## COMPLIANCE WITH CONDITION 6(a) and 6(d)

**Reg Ref:** SD21A/0326  
**Location:** Proposed Residential Development at Gordon Park, Old Naas Road, Kingswood, Dublin 22.  
**Applicant:** Greenwalk Development Ltd.

**Figure 1 – Screenshot from lighting plan indicating limited illumination of sensitive eastern boundary**

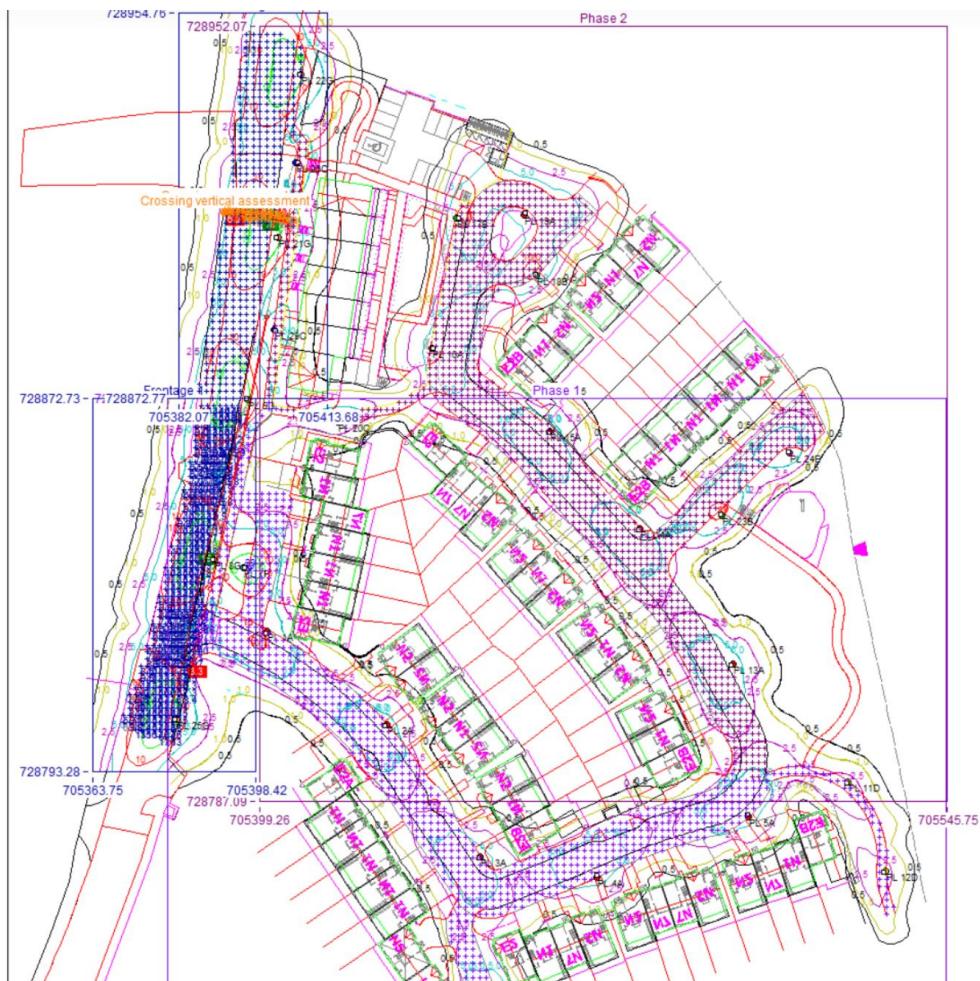
Gannon + Associates have reviewed the reviews Public Lighting Plan prepared by Patrick Redmond and are satisfied that the scheme provides an adequate balance between the public safety at night and ecological photoreceptors. We can confirm that the detail of measures described under "Mitigation Measure 4: Night Time Lighting" in the Ecological Impact Assessment has been adhered to in this final lighting plan.

- The lighting configuration has been carefully selected to achieve recommended illuminance levels whilst minimising light spill and avoiding over lighting. This is achieved by a combination of optimised column height, luminaire Wattage, optical setting and column location for each road configuration.
- All luminaires proposed have high performance street lighting specific optics designed to get the light onto the target area thus minimising spill light.
- All luminaires proposed have a 0 degree tilt.

- The ULR of all proposed column mounted luminaires is 0%.
- All luminaires are to be neutral white colour temperature with peak wavelength of above 550nm and max.
- All column mounted luminaires are to be fitted with photocells which automatically switch luminaires on during night time and off during daytime.
- Additionally, all column mounted luminaires are to automatically dim to 75% 00:00 – 06:00 (U14 profile). If required and with agreement of the local authority additional dimming is available.
- No direct lighting of existing hedgerow at eastern boundary and proposed tree and hedge planting.
- Green space to remain largely unlight.
- Vertical light spill at light sources is below 3m.
- No floodlighting is proposed.
- Night timer lighting kept to a minimum during construction phase.
